# UNITED STATES PATENT AND TRADEMARK OFFICE

APPLICATION NO.	FILING DATE	FIRST NAMED INVENTOR	ATTORNEY DOCKET NO.	CONFIRMATION NO.
10/679,697	10/07/2003	Choong Un Lee	054358-5017	3567
9629	7590	09/08/2005	EXAMINER	
MORGAN LEWIS & BOCKIUS LLP 1111 PENNSYLVANIA AVENUE NW WASHINGTON, DC 20004			DUONG, THOI V	
			ART UNIT	PAPER NUMBER
			2871	
DATE MAILED: 09/08/2005

<b>Office Action Summary</b>	<b>Application No.</b>	<b>Applicant(s)</b>
	10/679,697	LEE ET AL. 
	<b>Examiner</b>	<b>Art Unit</b>
Thoi V. Duong	2871

## **DETAILED ACTION**

**FIG. 8A**

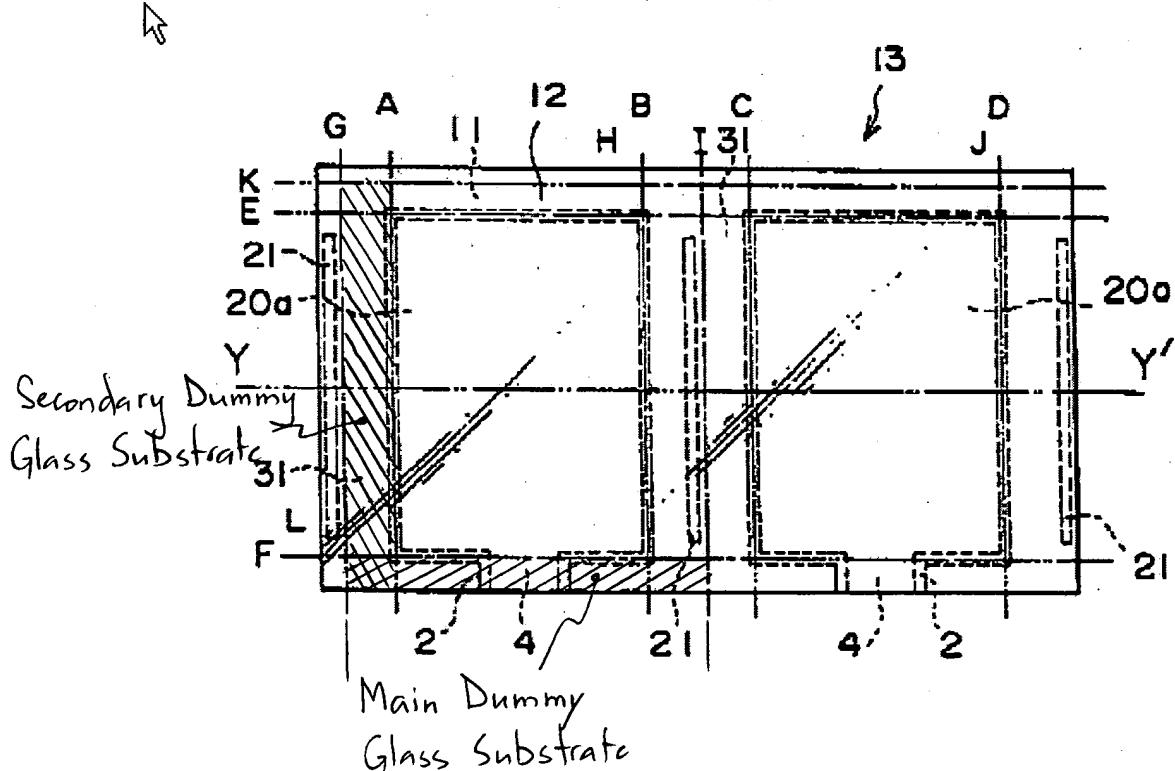
separating liquid crystal display panels 20a from the attached mother substrates, wherein the attached mother substrates include main dummy glass substrates and secondary dummy glass substrates divided by the first and second cutting lines A, F, and G, and the sealant pattern 2 is located underneath the first cutting line F between the main dummy glass substrates and the secondary dummy glass substrates (underneath the terminal portion 31) (see Fig. 8A below).

Re claim 5, the sealant pattern 2 is positioned on both the main dummy glass substrates and the second dummy glass substrates as shown below in Fig. 8A.

**FIG. 13**

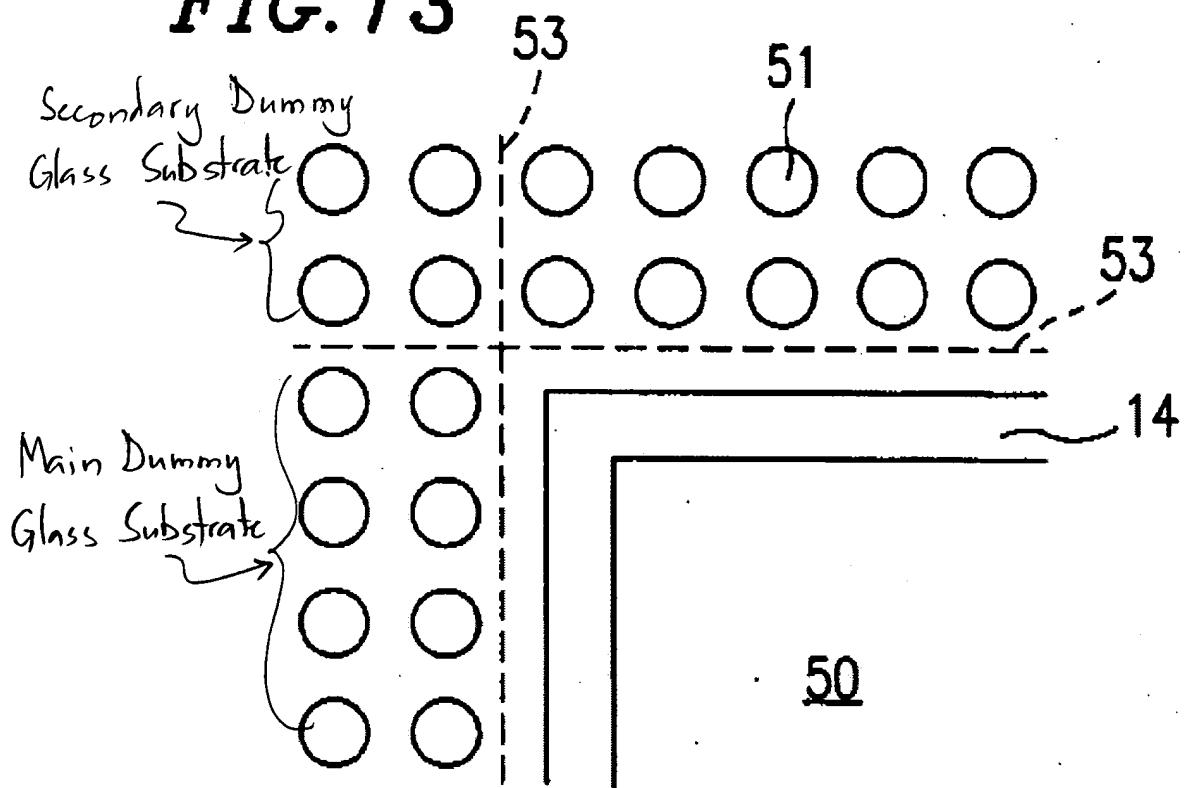
As shown in Figs. 2 and 13, Nakahara discloses a method of fabricating a liquid crystal display panel 50 comprising forming a plurality of dummy glass substrates 22 (seal formation area) including main dummy glass substrates (vertical portion) and secondary glass substrates (horizontal portion) around sealant patterns 14 (see Fig. 13 below), wherein the dummy glass substrates comprises sealant particles 51 having a diameter of 0.2 mm and an interval of 0.6 mm between adjacent sealant particles (col. 12, lines 30-42). Accordingly, the width of the dummy glass substrates in Fig. 13 is less than 3 mm. Also, the sealant patterns 14 are positioned on both the main and secondary dummy glass substrates.

Further, as shown in Figs. 2 and 13, Nakahara discloses a method of fabricating a liquid crystal display panel 50 comprising forming a plurality of dummy glass substrates 22 (seal formation area) including main dummy glass substrates (vertical portion) and secondary glass substrates (horizontal portion) around sealant patterns 14 (see Fig. 13 above), wherein the dummy glass substrates comprises sealant particles 51 having a diameter of 0.2 mm and an interval of 0.6 mm between adjacent sealant particles (col. 12, lines 30-42). Accordingly, the width of the dummy area in Fig. 13 is less than 3 mm.
